**Re: Kimber Residence  
0 Pinecrest Parkway**

This letter is to request that the Steep Slopes and View Preservation Review be continued at the February 16, 2020 meeting of the Planning Board.

- A. An alternative design for the house consisting of three sheet of drawings prepared by Gotham Design & Community Development Ltd. under the review of Laura Wakefield, R.A., dated as submitted January 30, 2020, for the Planning Board.
- B. A Narrative documenting the fact that the subject property has steep slopes and making a request for a Special Hardship Exception from the Planning Board to permit the limits stipulated in the Code under Section 240-5.A. to be exceeded.

**SP-3**

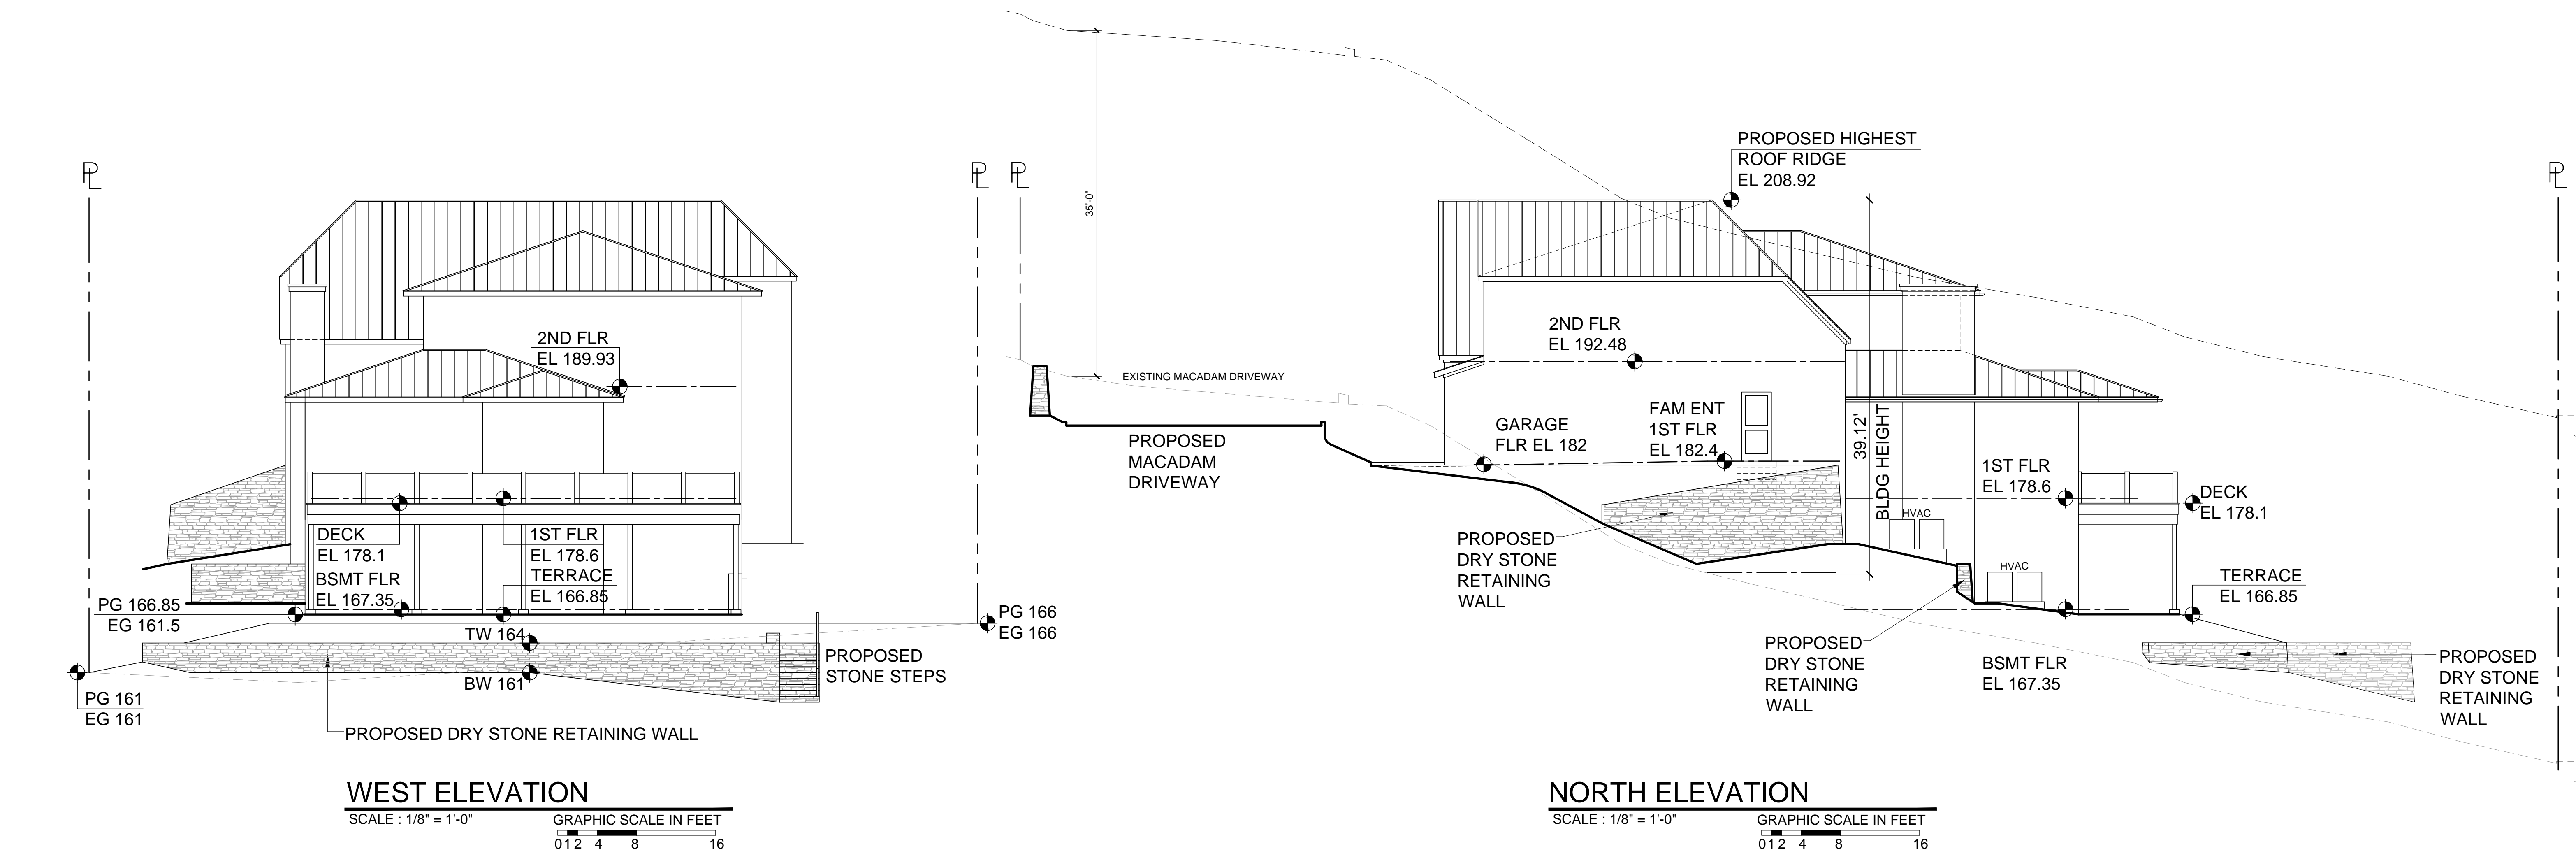
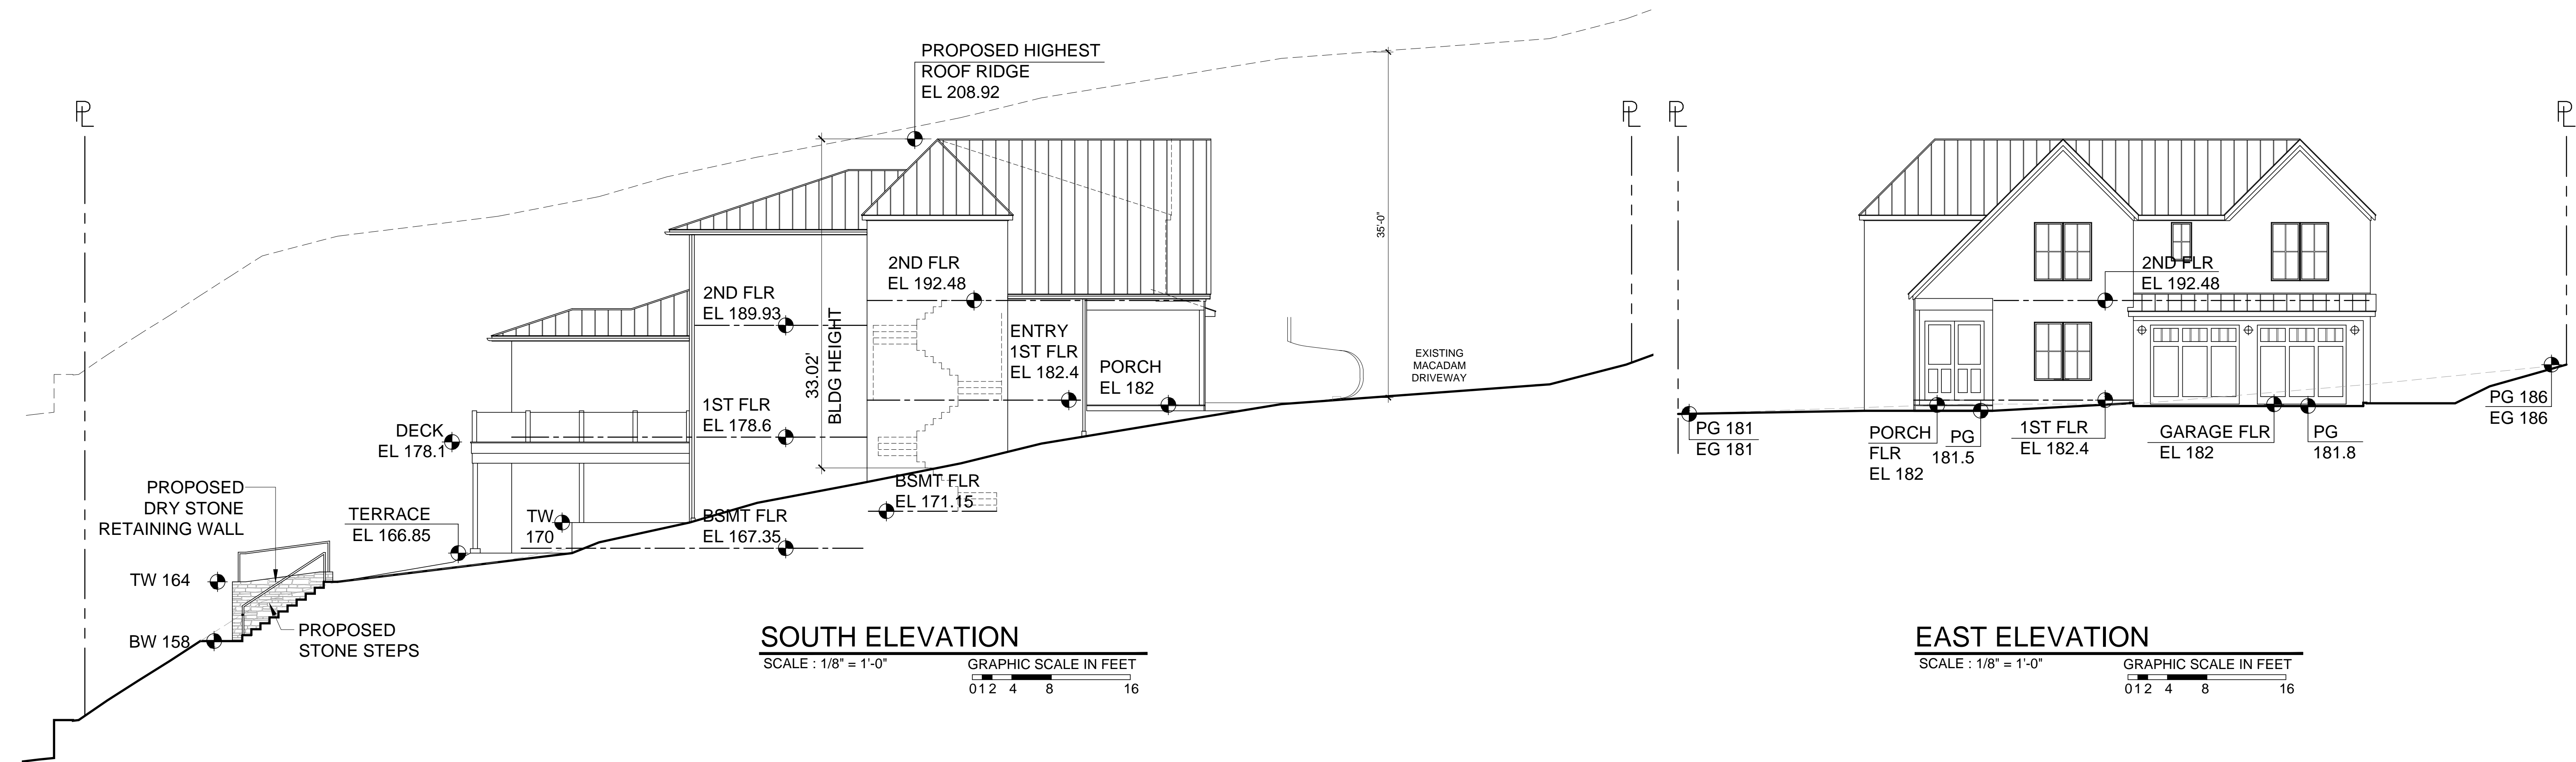
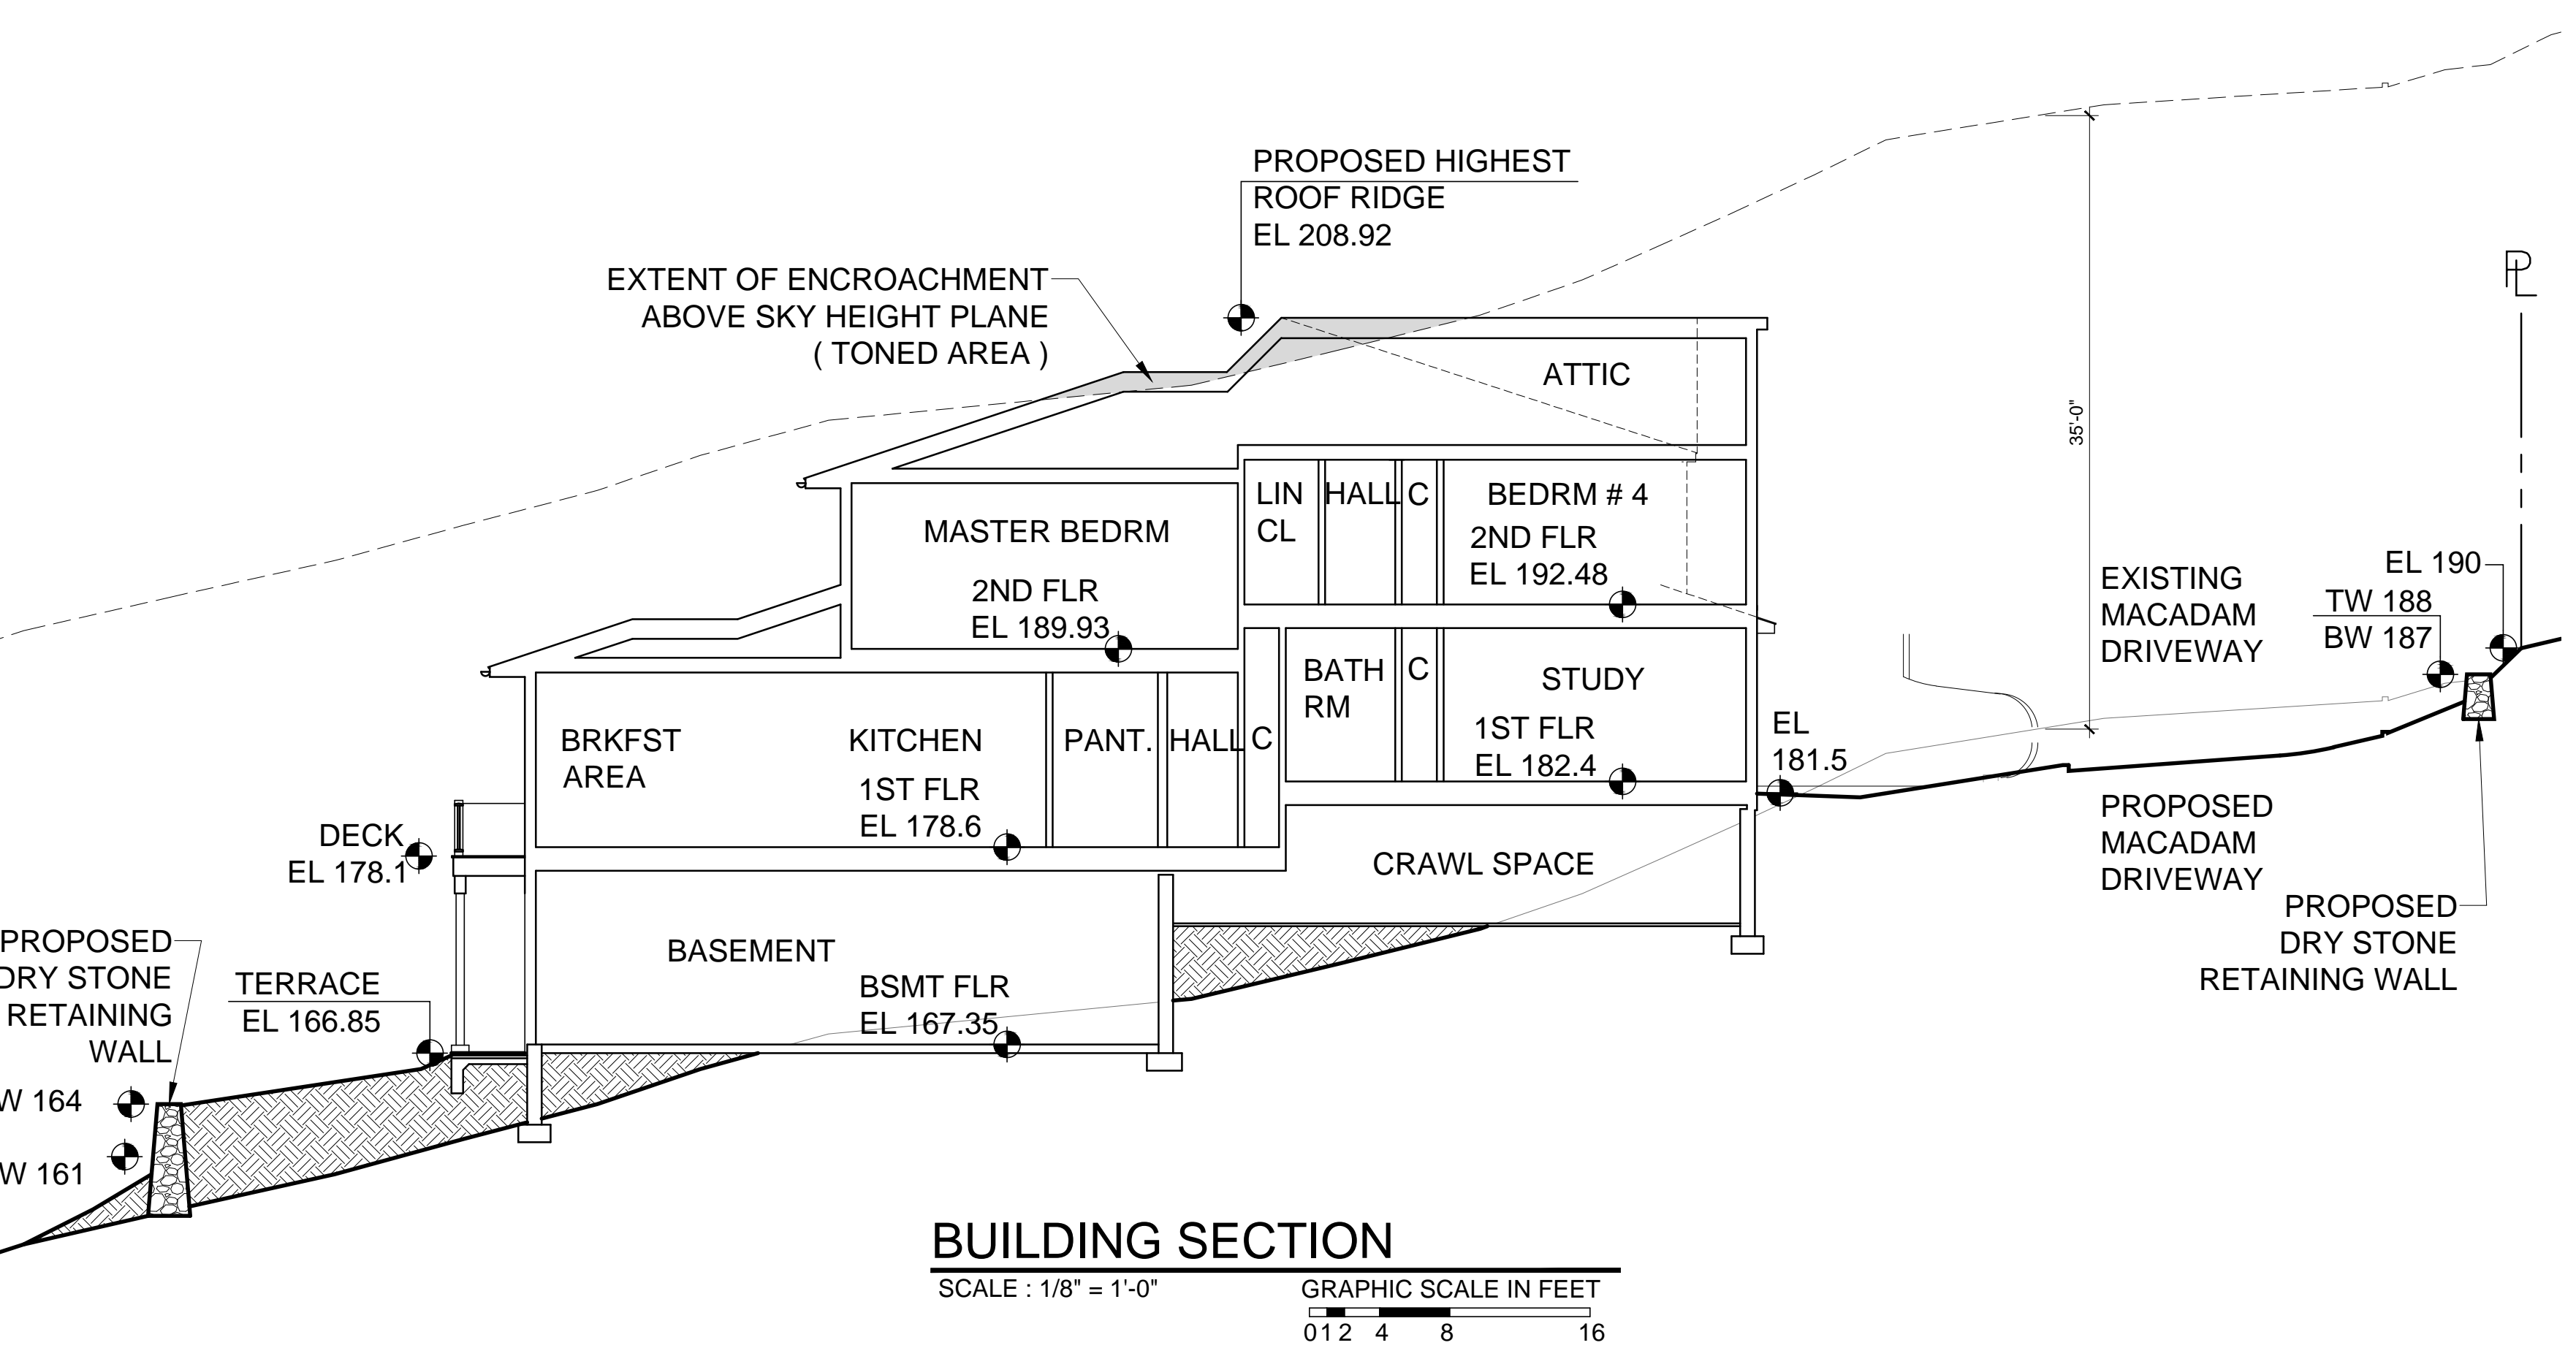
5. The height of the house has been reduced from a ridge elevation of 209.29 feet to a ridge elevation of 208.92. There is still a technical encroachment above the 35 foot sky plane, but as noted at the meeting, this is not a result of the house projecting higher but of a small area of the site dropping into the ravine lower. The grade at the front of the house is at approximately el.182, which makes the height of the house to the highest point of the ridge 26 feet as measured at the front. For comparison, the existing house at 115 Pinecrest Parkway has a ridge elevation of 208 with the grade at the curb at elevation 181. By contrast the existing curb elevation in front of the proposed house is elevation 185. (See Note 8 below).
